AMENDMENT OF SOLICITATION/MODIFICATION OF CONTRACT			1. CONTRACT ID CODE	PAGE OF PAGES 1 OF 6
2. AMENDMENT/MODIFICATION NO. A-002	3. EFFECTIVE DATE 4/3/2018	4. REQUISITION/PURCHASE REQ. NO. PR7169143	5. PROJECT NO. (If applicable)

14. DESCRIPTION OF AMENDMENT/MODIFICATION (Organized by UCF section headings, including solicitation/contract subject matter where feasible.)				
<p>This amendment is issued to answer questions that have been asked by potential offerors. See pages 2-6.</p>				
15A. NAME AND TITLE OF SIGNER (Type or print)		16A. NAME OF CONTRACTING OFFICER Jason Haskins		
15B. NAME OF CONTRACTOR/OFFEROR BY _____ (Signature of person authorized to sign)		15C. DATE SIGNED	16B. UNITED STATES OF AMERICA BY (Signature of Contracting Officer)	16C. DATE SIGNED 4-3-2018

Questions and Answers

Photo #5

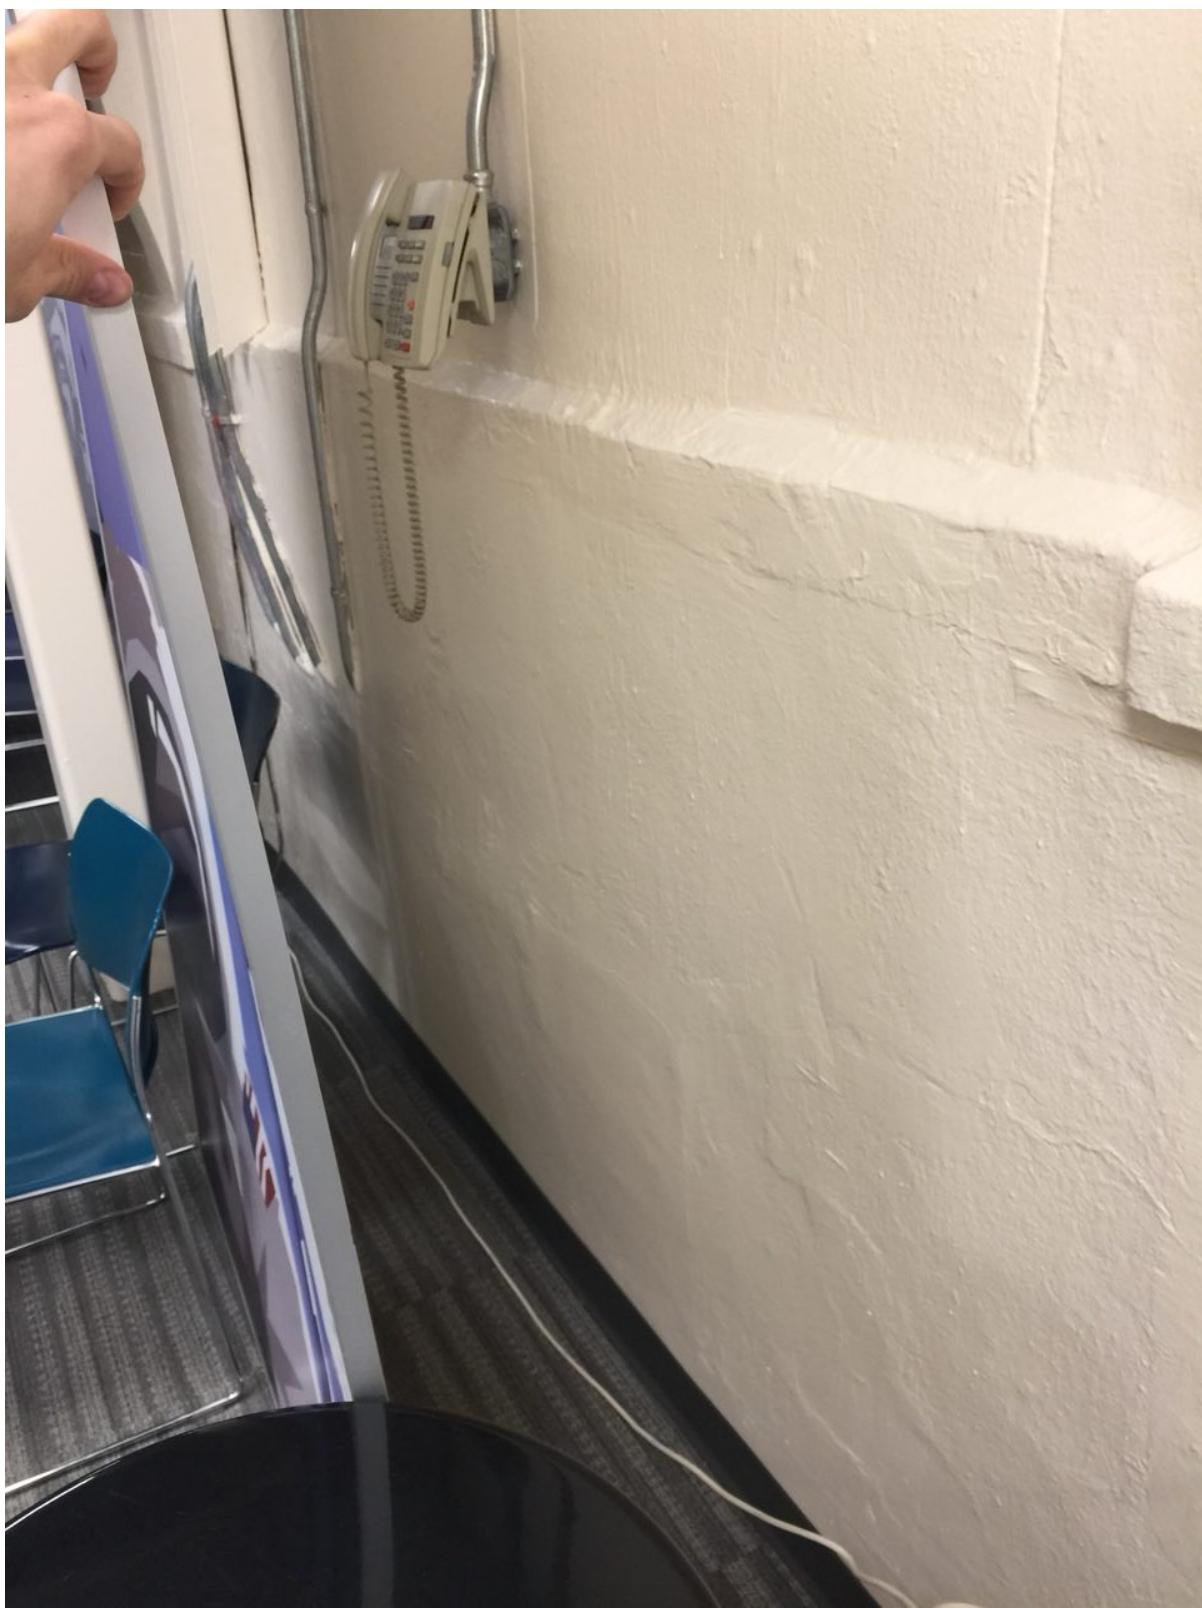
Q5: Please provide a photo of the connection point #2.

Q6: Please provide a photo of the spot where the heating system pipes run into the Am Center's hall.

A5: See photos on pages 3-6.

A6: See photos on pages 3-6.
